**ANCHORAGE, ALASKA
AO No. 2023-60**

1 **AN ORDINANCE OF THE ANCHORAGE MUNICIPAL ASSEMBLY APPROVING**
2 **THE BASIS-OF-DESIGN CONCEPT SUBMITTED BY THE PORT OF ALASKA**
3 **MODERNIZATION PROGRAM AND DESIGN ADVISORY BOARD THAT WILL**
4 **GOVERN THE PHASE 2 MODIFIED CONCEPT FOR THE PORT OF ALASKA**
5 **GENERAL PURPOSE CARGO TERMINALS.**
6

No. AM 346-2023

2
3 **SUBJECT: AN ORDINANCE OF THE ANCHORAGE MUNICIPAL ASSEMBLY**
4 **APPROVING THE MODIFIED BASIS-OF-DESIGN CONCEPT**
5 **SUBMITTED BY THE PORT OF ALASKA MODERNIZATION**
6 **PROGRAM (PAMP) AND DESIGN ADVISORY BOARD (DAB)**
7 **THAT WILL GOVERN THE PHASE 2 MODIFIED CONCEPT FOR**
8 **THE PORT OF ALASKA (POA) GENERAL PURPOSE CARGO**
9 **TERMINALS.**

Proposed Cargo Dock Basis of Design

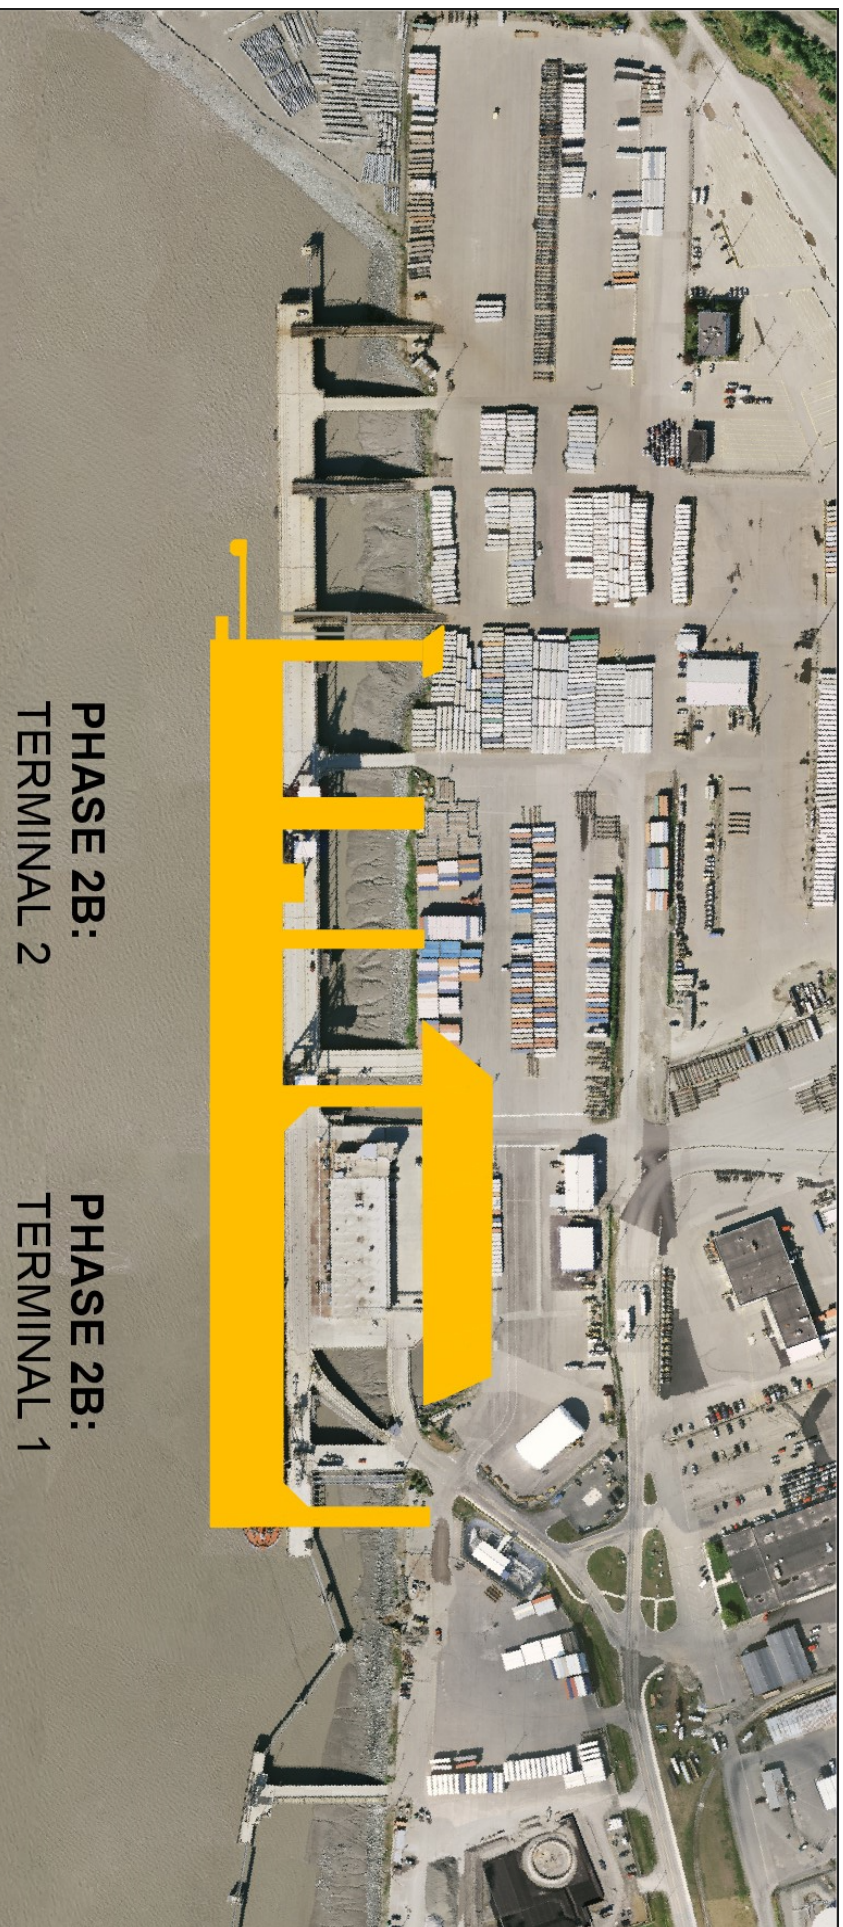
14 **Section 1.** The Phase 2 Modified Concept Design for the Port of Alaska general
15 purpose cargo terminals is hereby modified to incorporate a continuous and
16 contiguous dock face, a uniform width, and 100-foot gantry cranes capable of being
17 used along the full length of Terminals 1 and 2, as depicted in the attached Exhibit
18 "A".

7 The modified cargo dock design, as proposed, utilizes a common industry design
8 with a contiguous dock face extending uniformly the entire length of the two
9 terminals, allowing any vessel the same opportunity to use either terminal, with full
10 cargo service available. The proposed layout accommodates the current fleet and
11 provides flexibility to service larger vessels in the future. What's more, there is
12 room for future expansion by constructing a third terminal. Exhibit "C" is an
13 illustration that shows how a future Terminal 3 could be constructed adjacent to
14 Terminals 1 and 2.
15

Current Cargo Dock Basis of Design (AO2021-56)

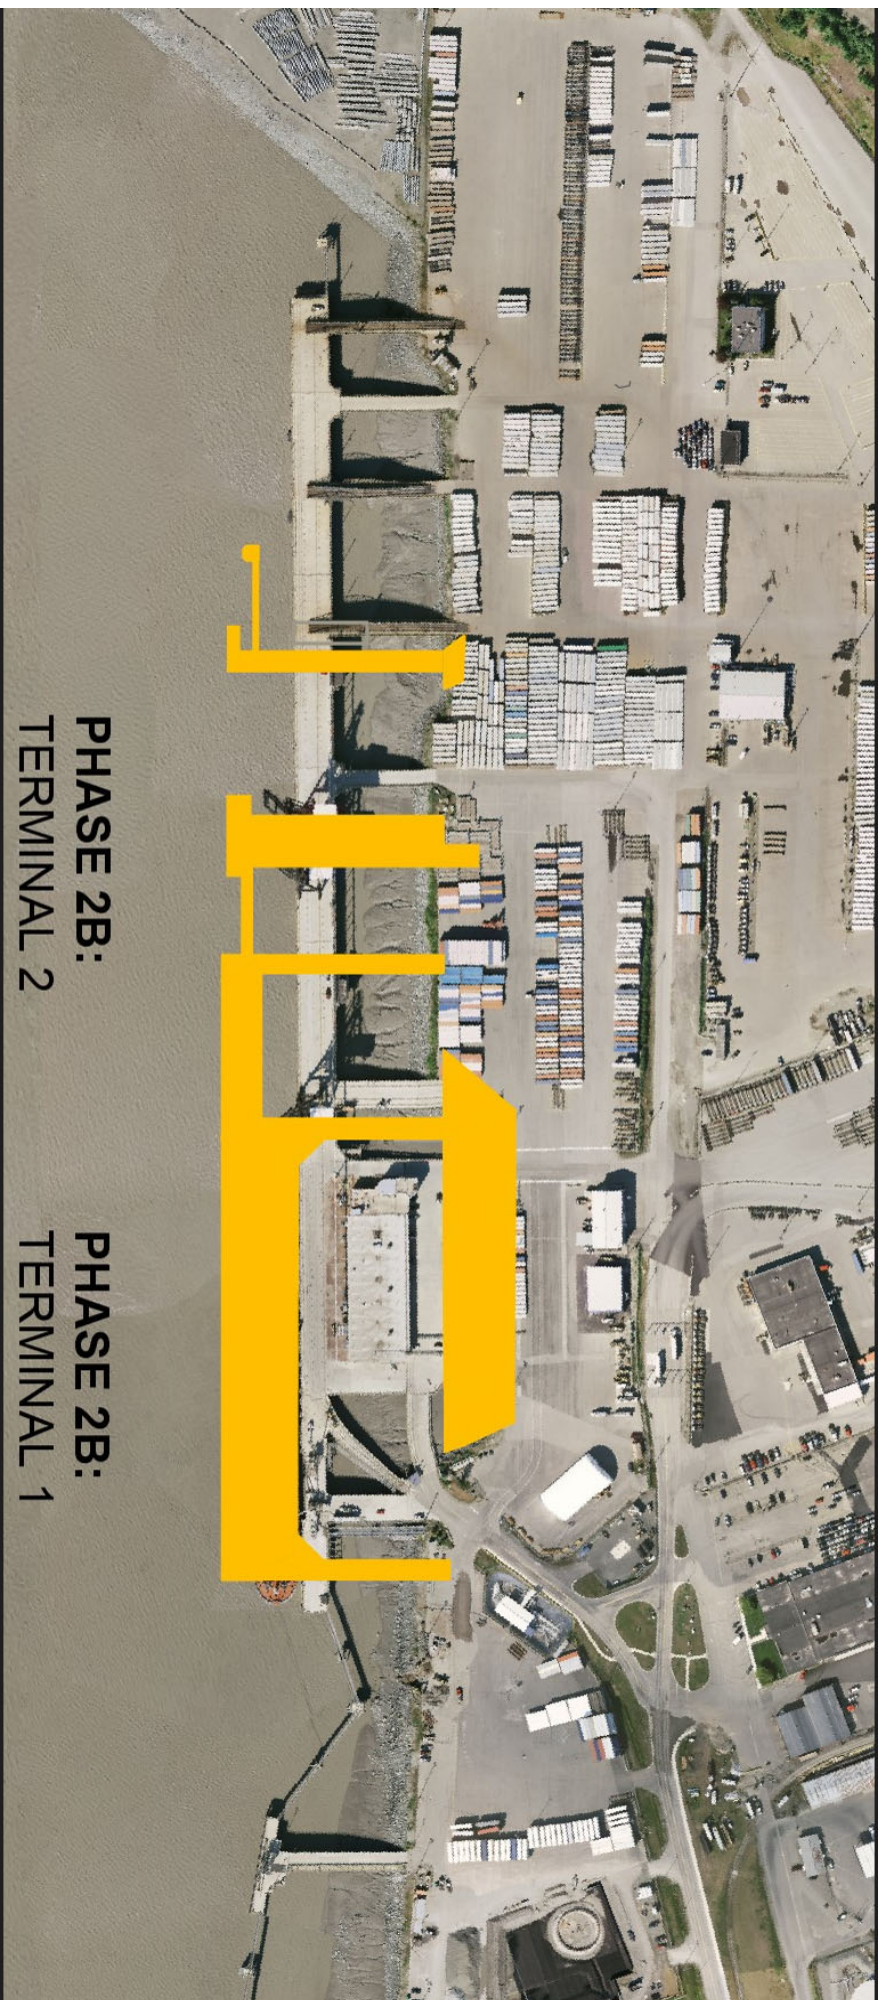
36
37 The design concept adopted in 2021 (AO No. 2021-56, depicted in attached Exhibit
38 "B") accommodates the current two vessels operated by TOTE at Terminal 2. This
39 design for Terminal 2 minimizes costs by providing only trestles for the roll on roll
40 off (RORO) operations. However, this also effectively removes any multi-use

1 capabilities and makes Terminal 2 essentially exclusive to the current user.
2 Because the dock is discontinuous, this concept provides no platform space to
3 unload/load cargo vessels by any other means, rendering cargo operations other
4 than TOTE's difficult or impossible to accommodate at that terminal. As a result,
5 under this concept, all the other vessels that call on the POA must use Terminal 1.
6

Image 2.0 100-gauge option with initial non-functional backreach area

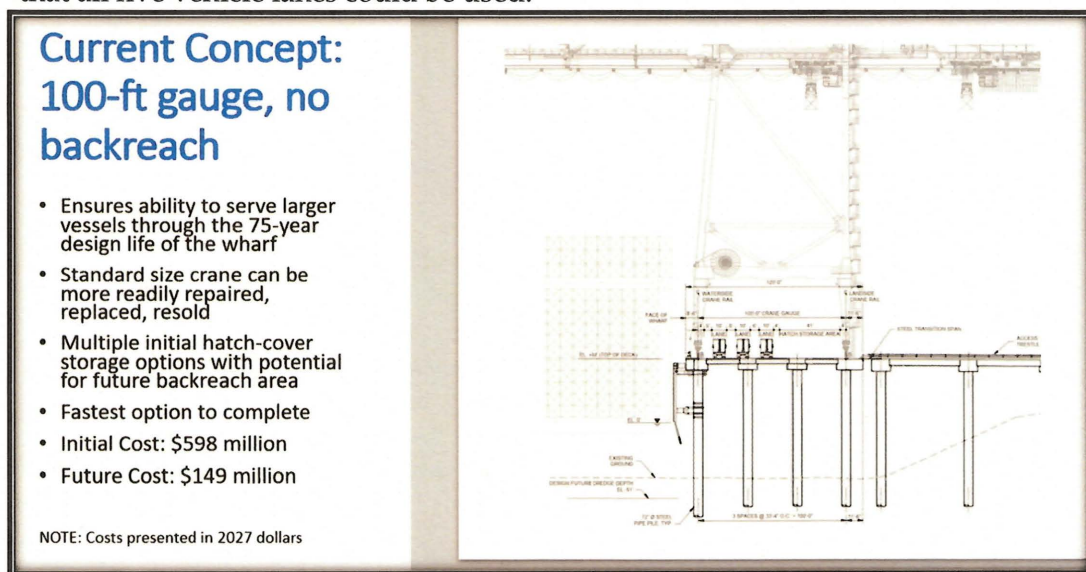
- (1) a 100-gauge crane accommodating option, which initially would have no “backreach area” for hatch covers; the option could result in five lanes of vehicle traffic, but two lanes would be sacrificed for hatch-cover storage; the initial cost of the option was projected to be \$598 million, but the costs would grow to \$149 million if the “backreach area” for hatch storage for was later made functional so that all five vehicle lanes could be used.

The remaining options, by contrast, all assumed that a “backreach” area would be built immediately; unsurprisingly, this resulted in significantly higher initial construction costs, even for docks accommodating smaller crane-gauges:
